▲ = Revised February, 1995

**No. 93-15**

## Rochester 4 Barrel Quadrajet Carburetor

**Figure 1.**

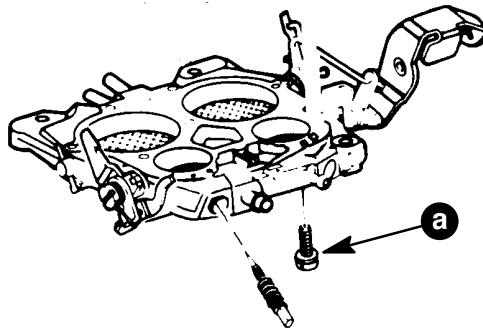
Possible cause could be air leak through carburetor mounting gasket. This gasket may leak in the area of the screw that holds the throttle body to the float bowl. This screw (a) is in a hole in the base of the carburetor, on the throttle lever side (Figure 1.). Because of this hole, the gasket may not be making an air tight seal. Remove carburetor from intake manifold. Inspect gasket to see if it has covered screw hole completely to seal out air leak. Do not remove screw, just fill screw hole with a silicone sealer. Using new mounting gasket, install carburetor. Torque carburetor mounting nuts and bolts to 20 lb. ft. (27 N·m).

(1) 27-52457--2 Mounting Gasket

### Incorrect Installation

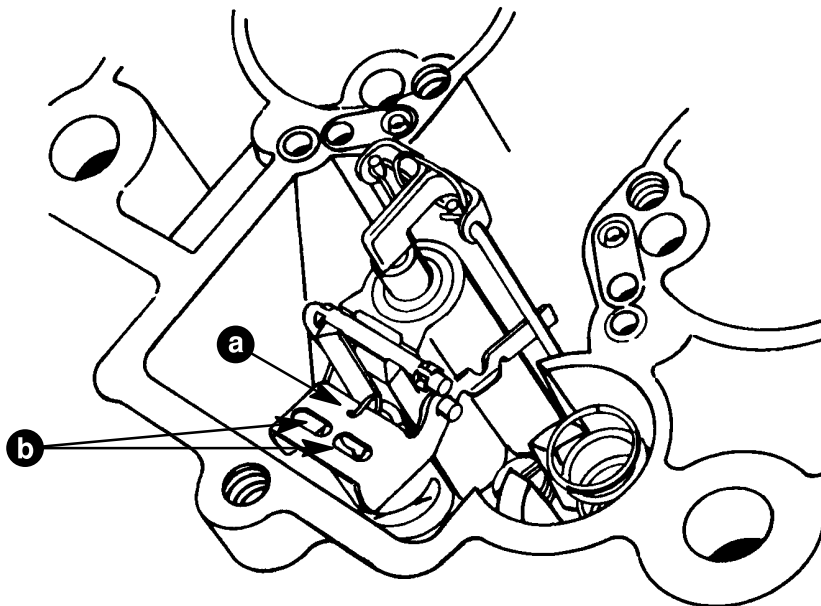
The engines that fall into the serial numbers listed may have the choke linkage installed incorrectly. If you experience this type of problem on an engine in the range given, check the choke rod for correction installation.

4.3LX 0C755446-0C755512

5.7L 0C755369-0C755396 and 0C755528-0C755592

### ▲ MCM 5.0LX Down in Power

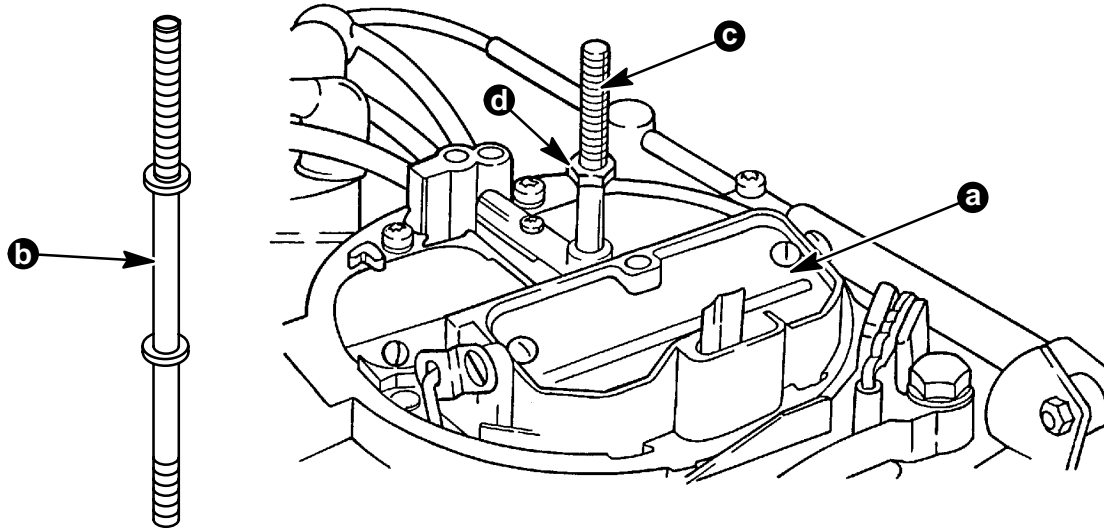
We have had some reports of this engine being down in power above 3000 RPM. To correct this problem, do the following;

1. Reset the secondary air valve (a) spring windup to 60 grams.
2. Replace the “stepped” flame arrestor stud, (b). Replacement stud doesn’t have “step”. The “stepped” stud could cause the secondary air valve to stick partially closed.

16-91842 Stud, (c).

11-28941 Nut, (d), to take the place of the upper step so flame arrestor doesn’t get over tightened.
